HOLLY TREE FARM
BROOKGATE WESTON

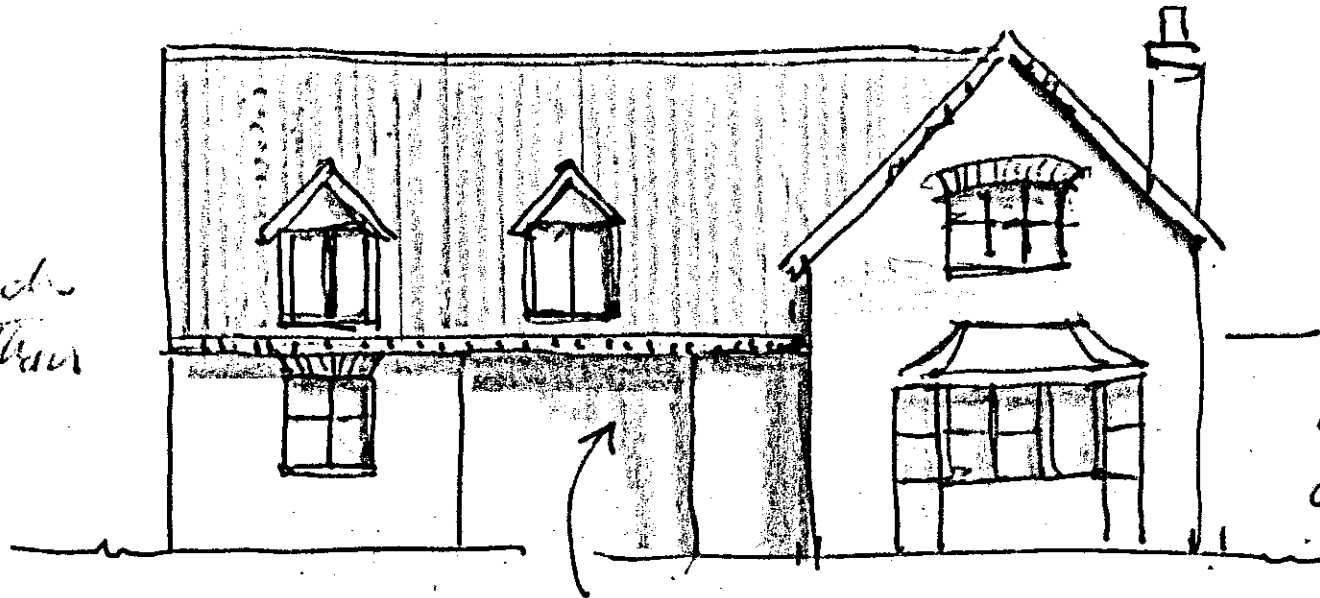
Clay pantile

To make the
bay distinctive
carry it down
in brick

Flat arch
rather than
soldiers

Client wished
to reduce width
of lounge

Suggest reducing
width of dormers
and placing them
near the eaves
(May have over-done
this)

I don't think the detail of
this opening works with courses of brick
'hanging' in the
air

Probably needs to be
narrower.

Have drawn this slightly too low
should sit under dentils
